Addendum #1

**Port of Port Arthur
Truck Queuing Area and Laydown Yard
Rider 37 Project 1 – CSJ 0920-38-288**

Addendum Date: August 21, 2025

CHAIN LINK FENCE DETAILS

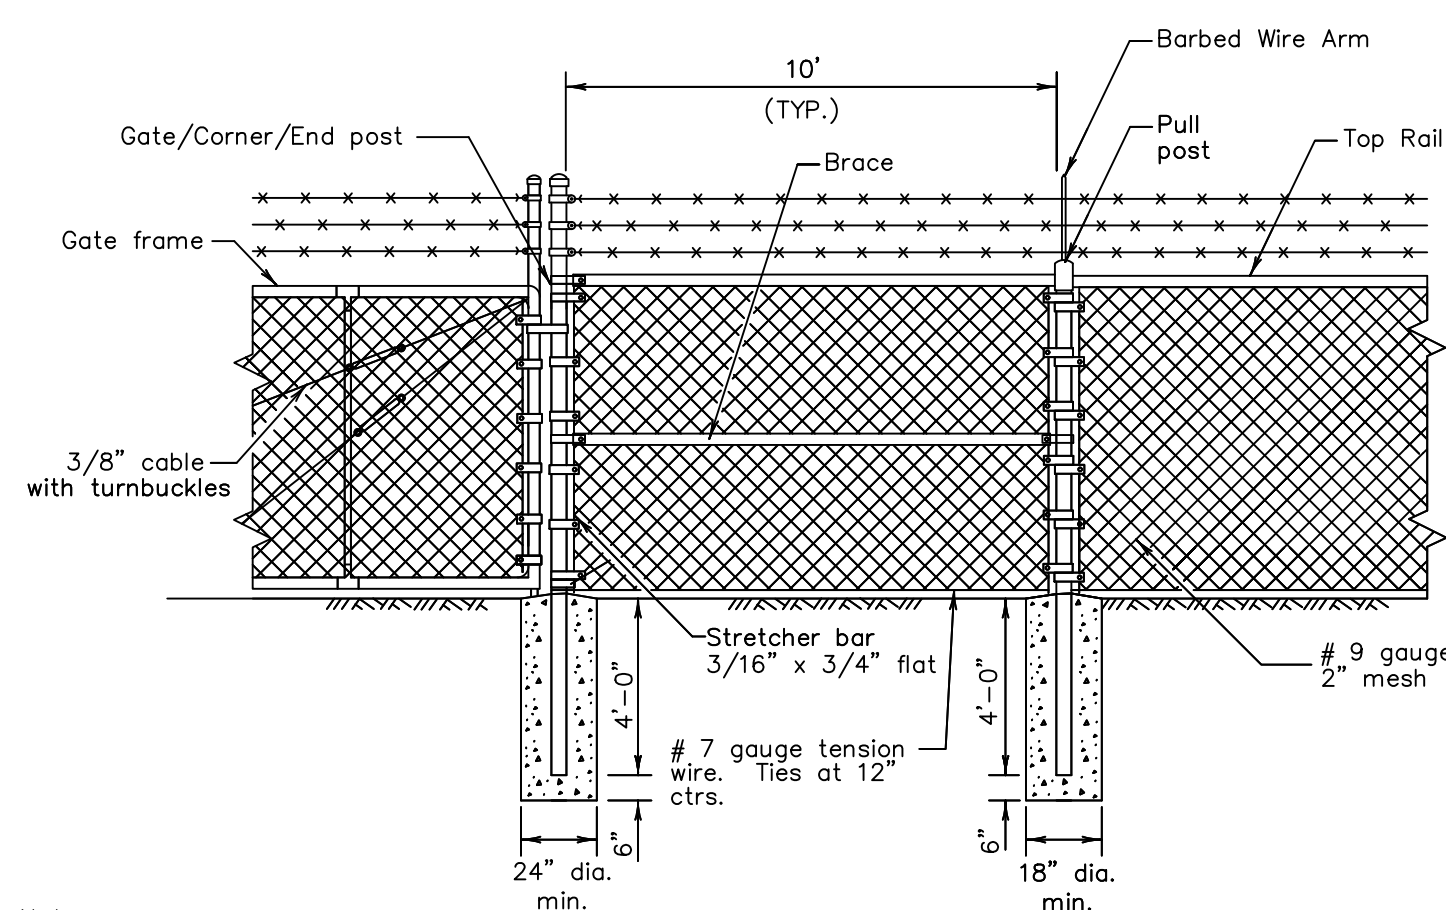
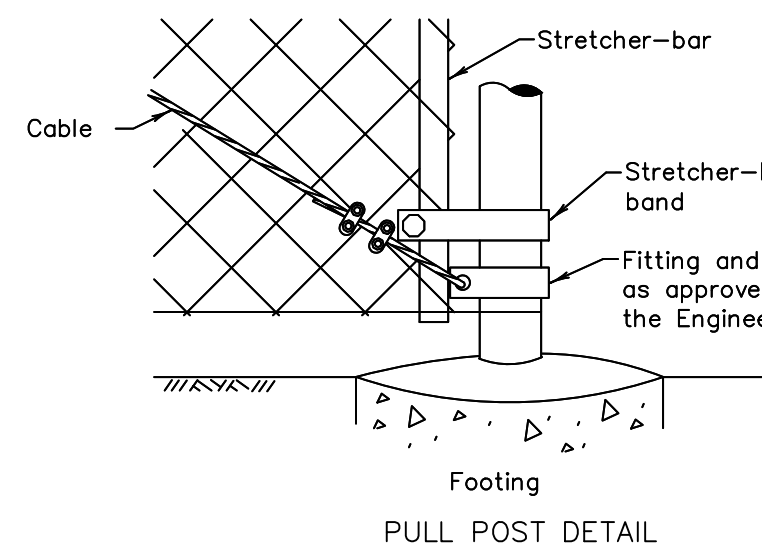
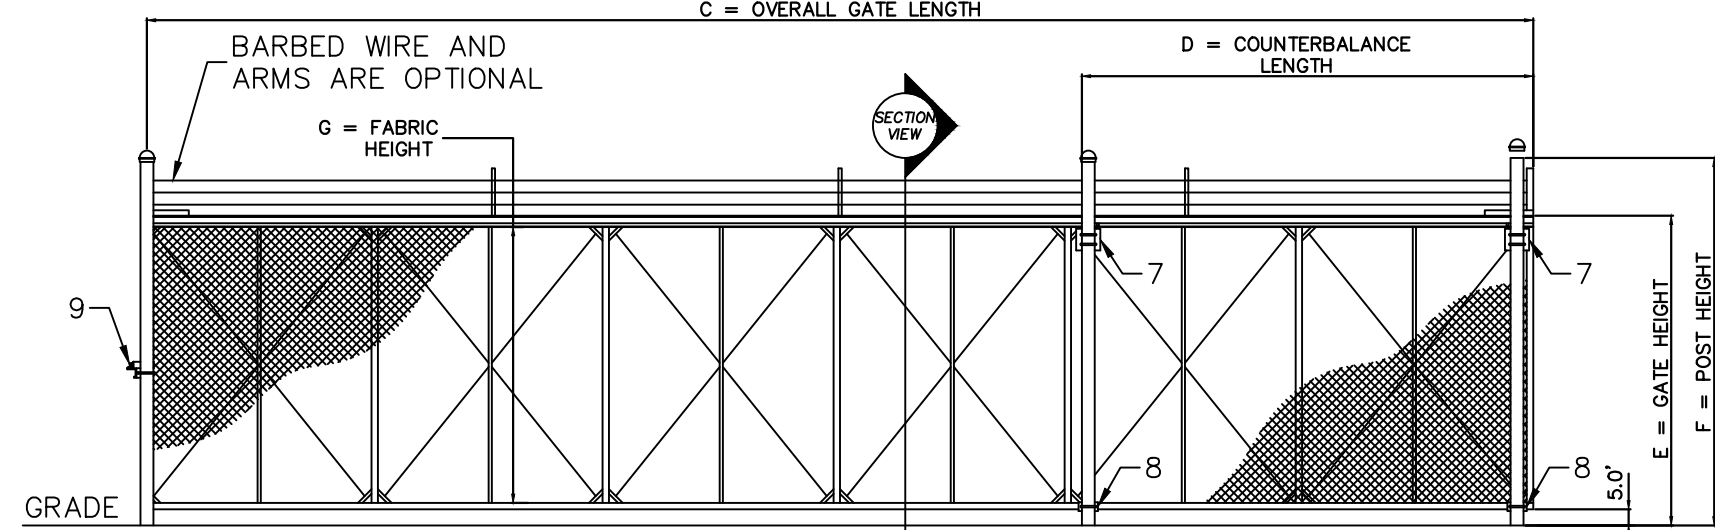
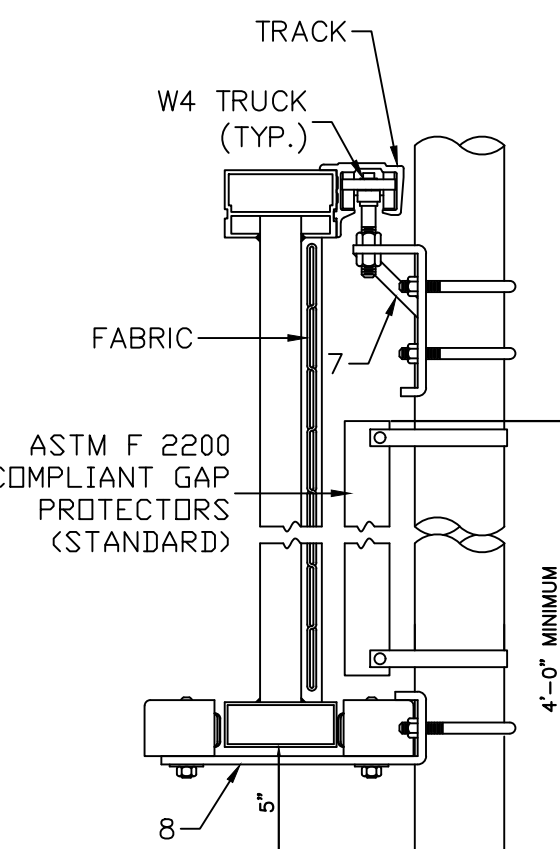
1. Demolition Plan updated to note buildings removed by port (sheet 4).
2. Turn Lane clarified as concrete paving with no asphalt (sheet 5).
3. Clarify trench details for CCTV (sheet 10).
4. Fencing details modified, top rail and bracing clarified, no bottom rail. Tension

wire clarified (sheet 12).

6. **Q:** Sheet 12, General Notes #7 calls for 1" mesh but Chain Link Details drawing calls for 2" mesh, please clarify.
A: 2" mesh is specified, notes have been updated. (general note numbers have changed).

7. **Q:** Sheet 12, General Notes #8 calls for top middle and bottom rails but Chain Link detail calls for 7ga bottom wire, please clarify.
A: Chain Link detail drawing has been updated, top rail is required, no bottom rails, tension wire spec updated, cross bracing requirements added (general note numbers have changed).

NO.	REVISION NOTES	DATE
1	MODIFIED FENCE DETAILS	8/20/2025

UPRIGHT CONCRETE CURB

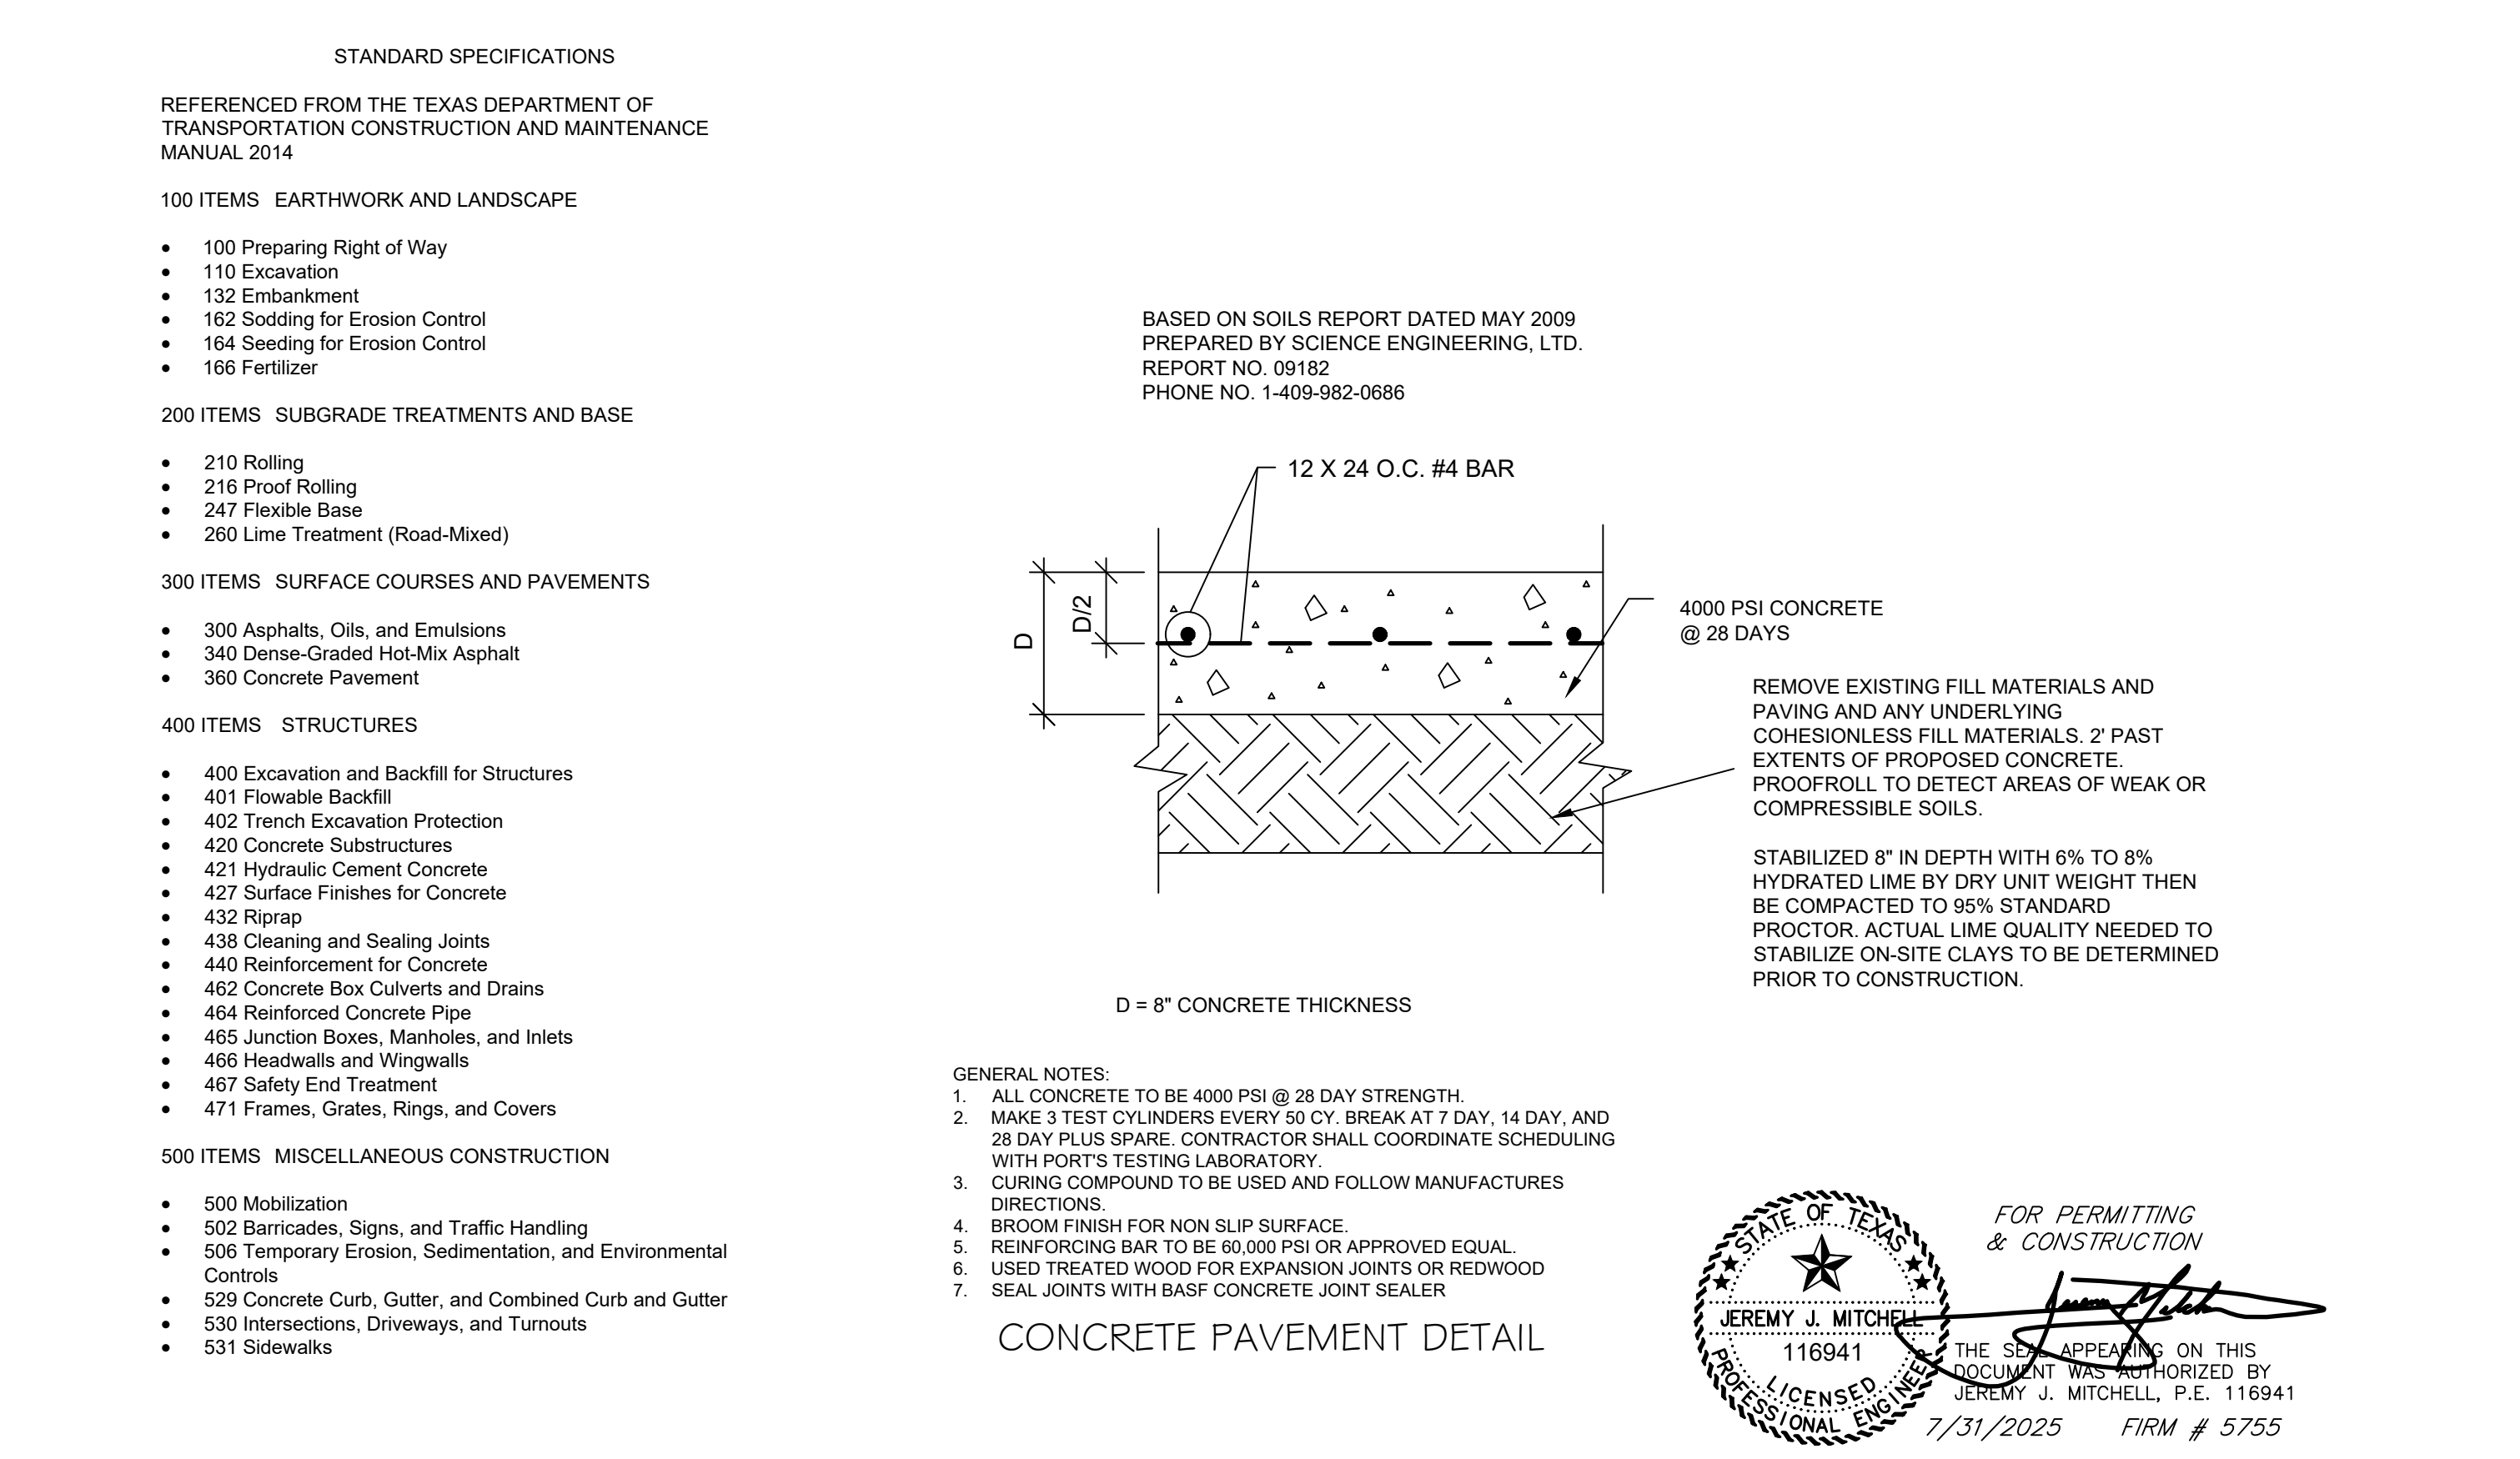
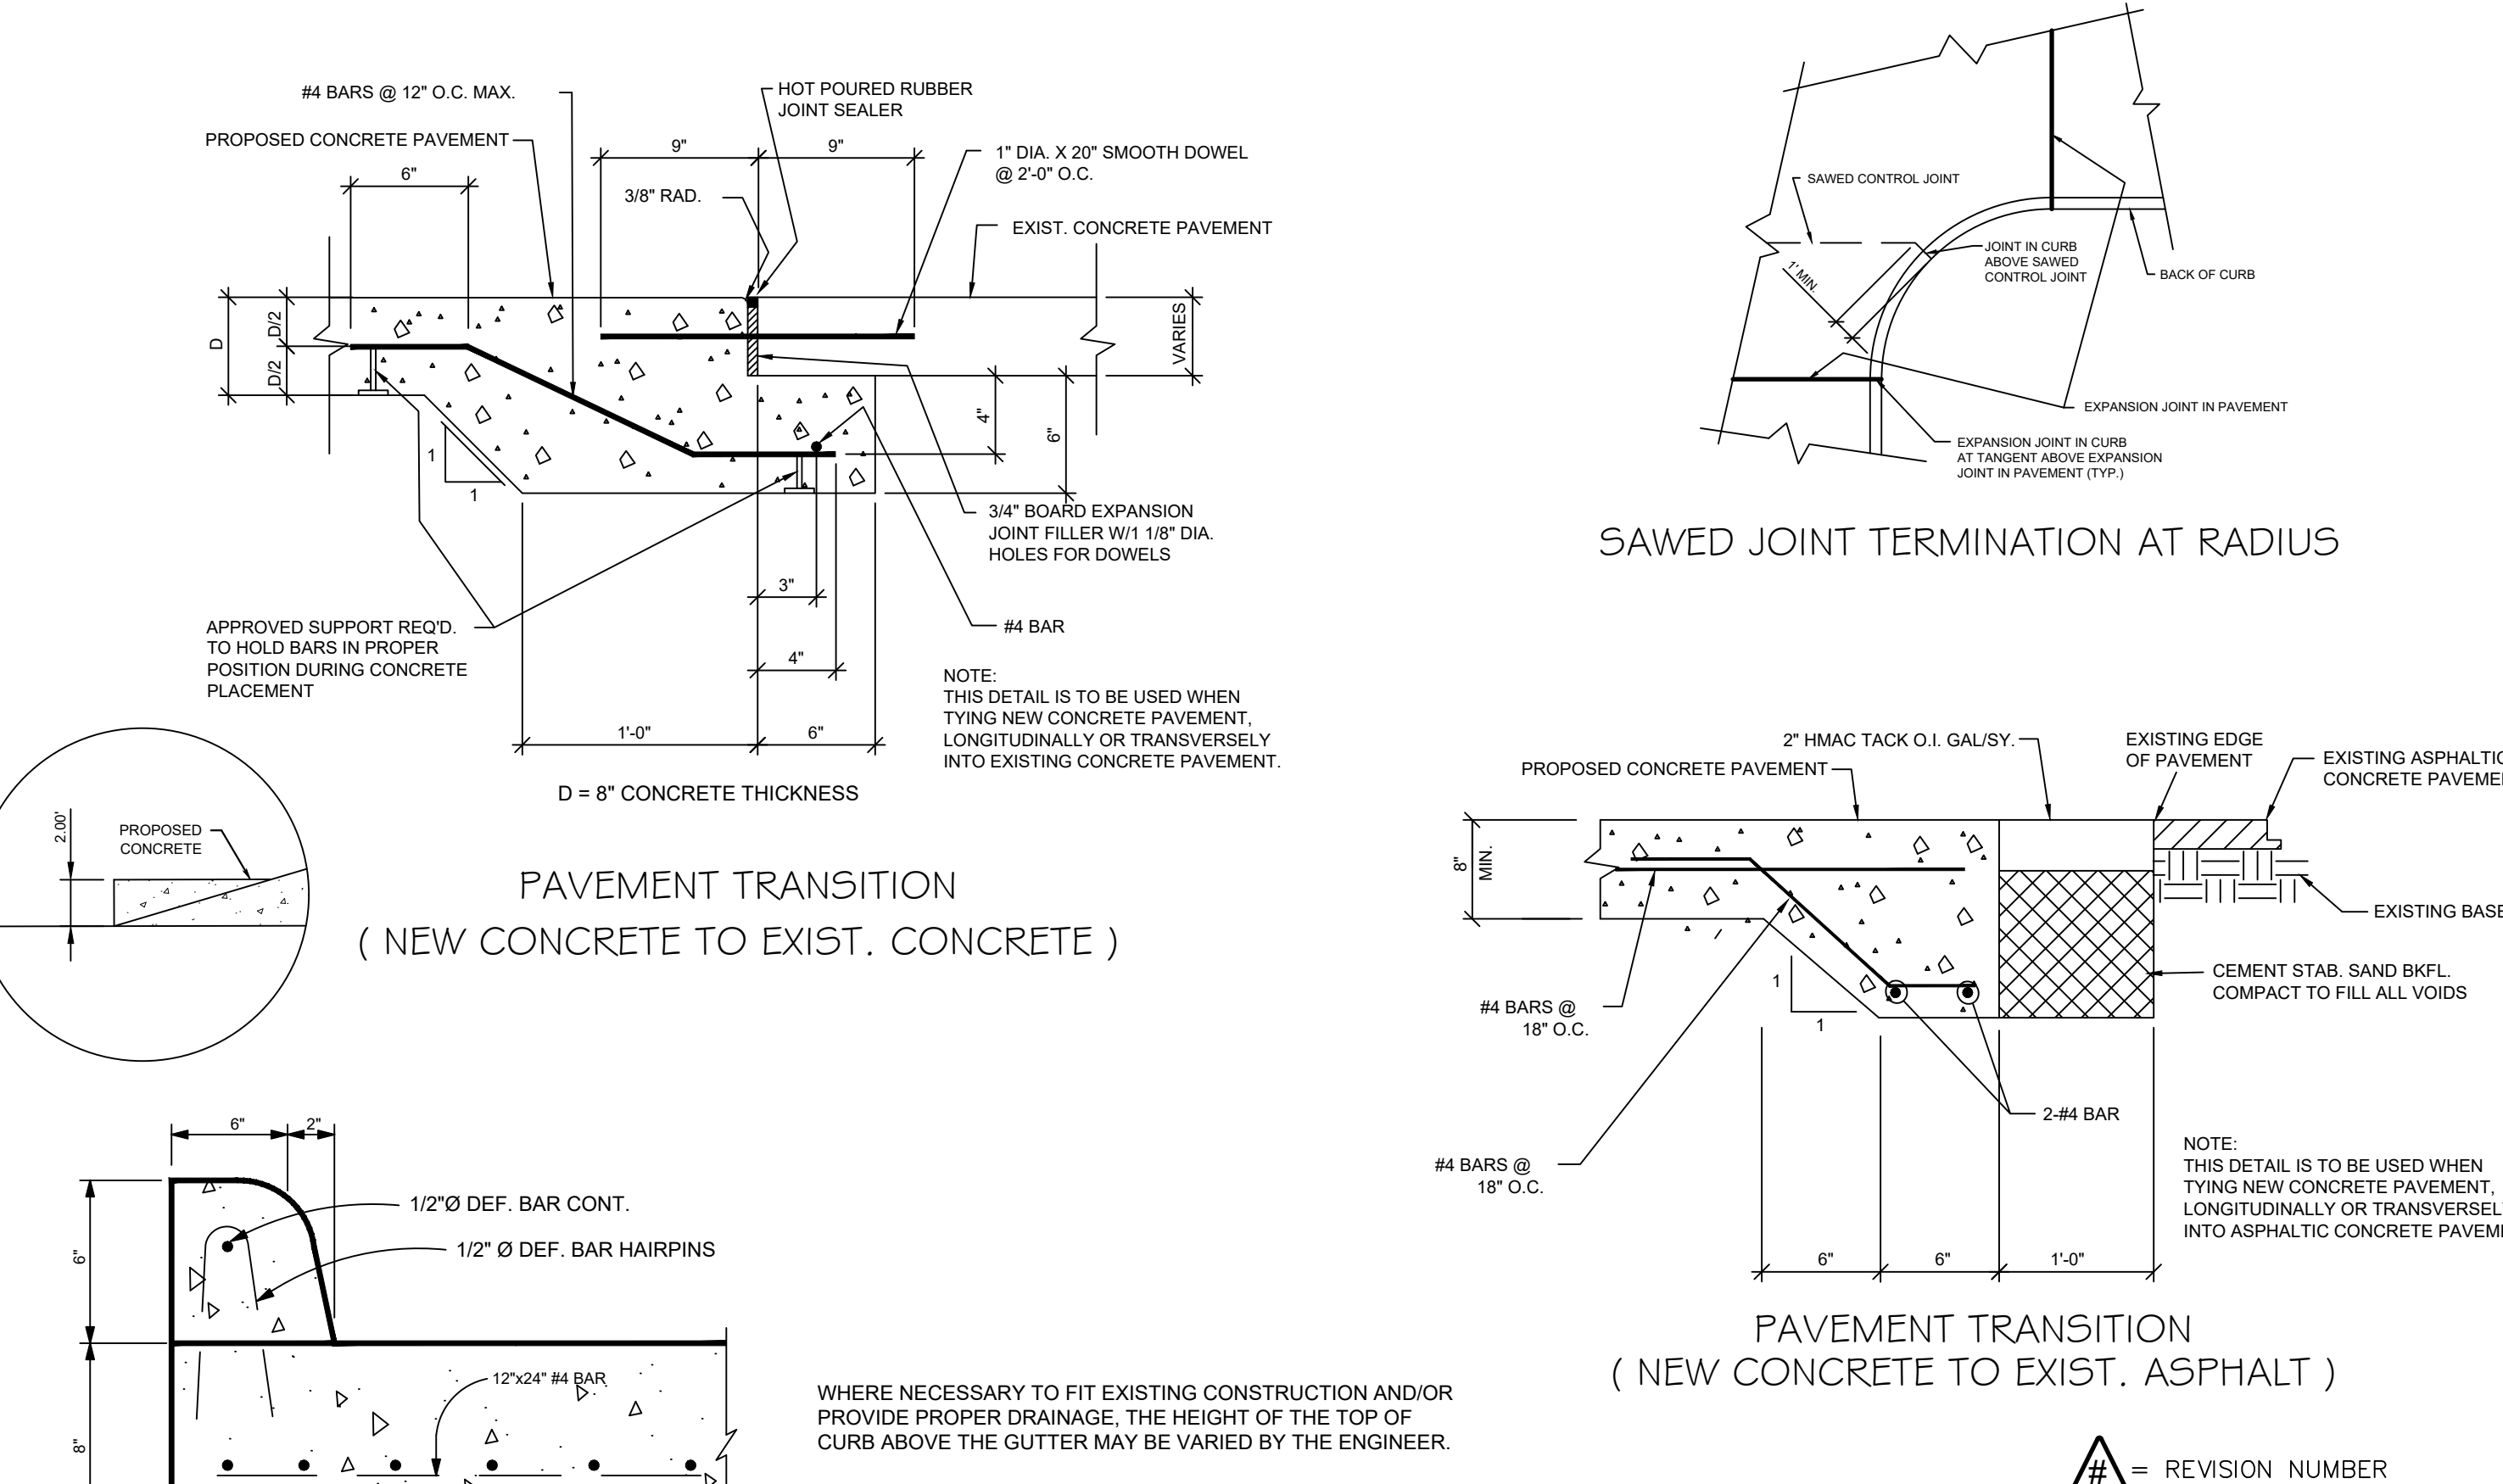
1. Bid items added (Demolition, Railroad Items, Traffic Control, etc.)
2. Steel casing around storm lines below rails, A36 standard wall thickness, smallest size necessary, no spacers. (30" steel on 24" hp, 24" steel on 18" hp) (sheet 8).
3. Rail work added to scope, remove and replace rails and ties (sheet 9).
4. Curb detail (sheet 13).

NO.	REVISION NOTES	DATE
1	ADDED CURB DETAIL	8/20/2025
